SD9 PCB Updates and comments

D.M. 8/10/2019

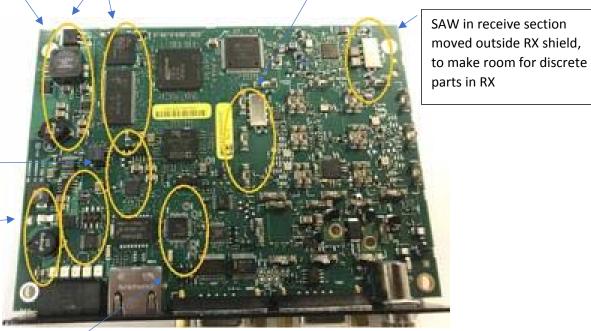
Moved power supply away from RF section

Memory/flash moved to right

When power supply moved to left, moved SAW filter closer to upconverter. Now under a shield

Same Ethernet drivers

Added DC/ESD input surge protection

CODEC moved slightly for production ease

No changes in the TRANSMIT section or TX parts changed.
